Cheshire West and Chester Council's Relevant Representation to Change Request 1 (CR1)

Wednesday 14 June 2023

This document represents a table of responses by Cheshire West and Chester Council ("the Council") to the Liverpool Bay CCS Limited ("the Applicant's") Change Request 1 in respect of the Applicant's application for development consent for the Hynet Carbon Dioxide Pipeline DCO ("the Project").

Reduction of the Order Limits to remove two residential properties and amenity curtilage at Grove Road Work No. 13 (Mollington) and Halls Green Lane Work No. 25 (South of Stanlow) (Applicant Reference PS11)

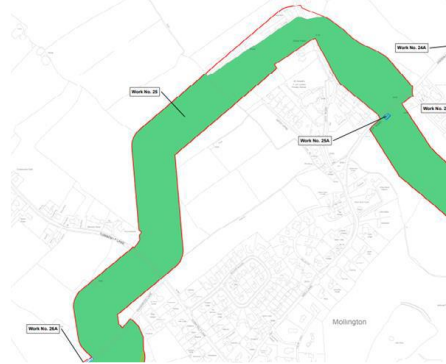
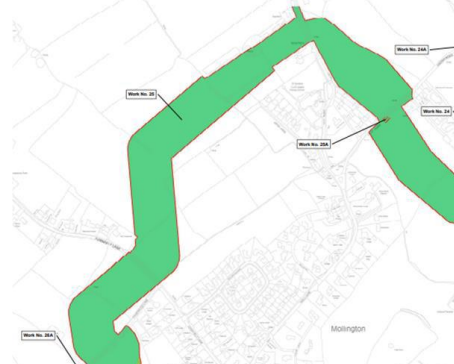
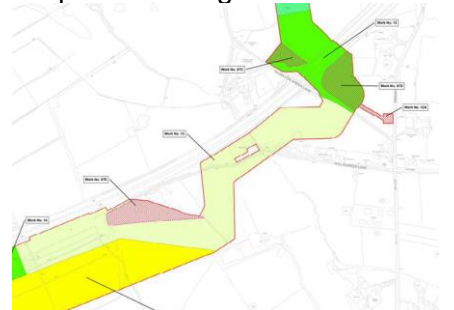
The Council has no comment.

Reduction of the Order Limits to remove part of the east bank of the River Gowy at Work No. 13A (Applicant Reference PS12)

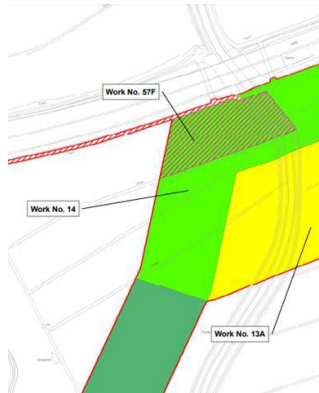
The Council has no comment.
